**CERTIFICATE OF APPROPRIATENESS**

**Property:** 602 Highland Street Lot 1, Block 29, Woodland Heights Subdivision. The property includes a historic 1,243 square foot one story single-family residence situated on a 5,000 square foot (50' x 100') corner lot.

**Proposal:** Alteration – Repair, Replace, Relocate windows/doors/openings with Rear Addition

**Recommendation:** Approval with conditions: based on criteria 4, 9

EAST SIDE ELEVATION

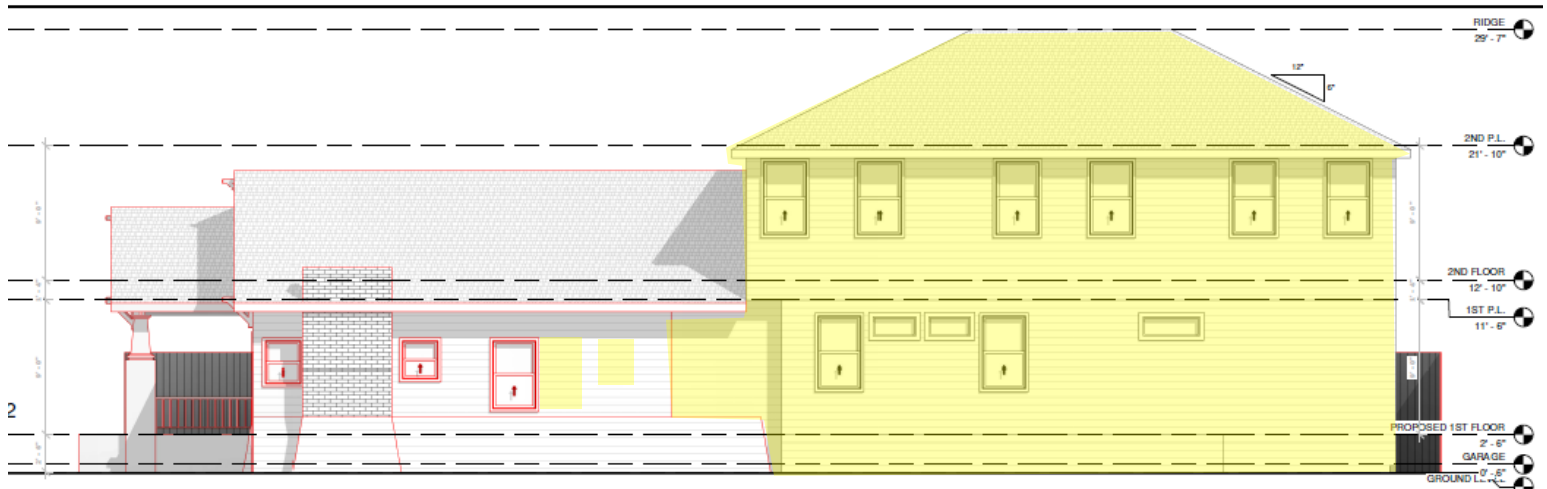
- East elevation: relocate three windows 11,10,9 to window 5 on east elevation/bump out on side street.
  - East elevation: Shorten two windows on east elevation visible from the side street - 7 and 6 to accommodate for relocation of kitchen counter

**Staff Recommends:** Repair of historic wood windows 7 and 6 on east elevation *or* relocate window 5 or 13 and find second window to match either one to relocate in openings of windows 7 and 6. Applicant to work with staff to confirm final paired windows in this location if historic materials cannot be found to match.

**WINDOW SCHEDULE – EAST SIDE ELVATION ALTERATIONS**

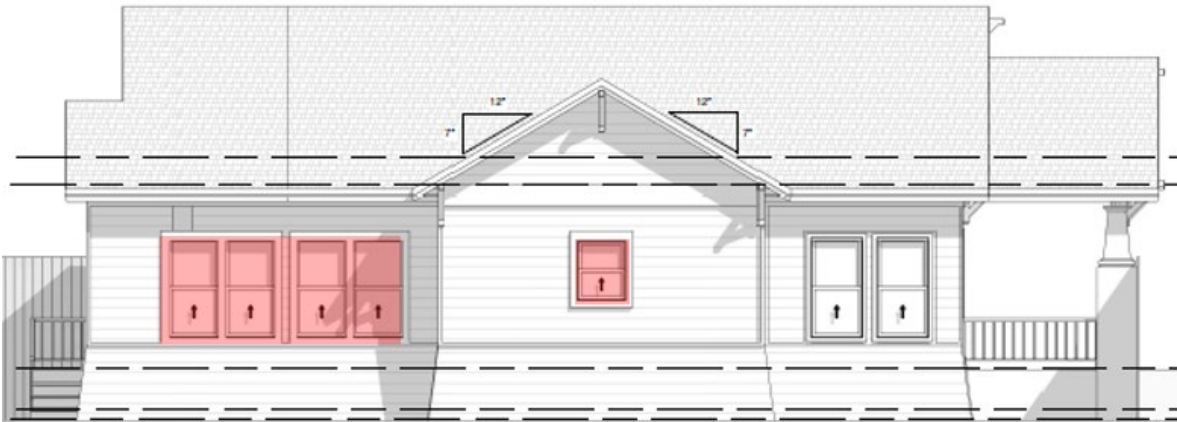
**WINDOWS: 10,9,8,7,6 PROPOSED REMOVAL & REPLACEMENT WITH 11,10,9 from side and rear**

**WINDOW SCHEDULE – WEST SIDE ELVATION ALTERATIONS**

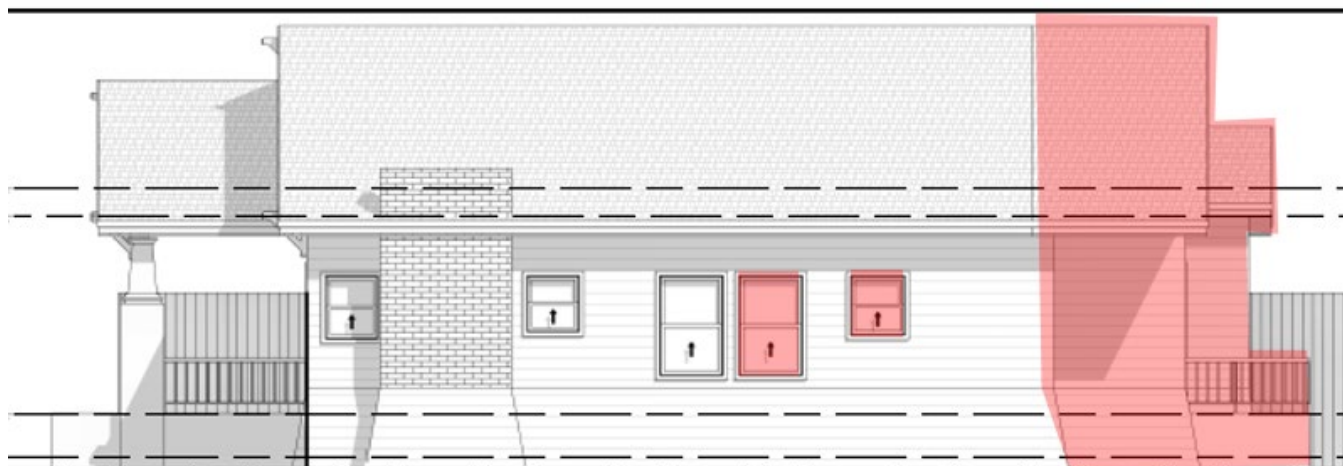
- South elevation/rear: two historic windows relocated (11,12 will be relocated to window 5 area)
  - West elevation two historic windows (13,14) will be removed, and cladding will be patched to match.

**WINDOWS: 14,13 PROPOSED REMOVAL AND CLOSED IN WITH SIDING**
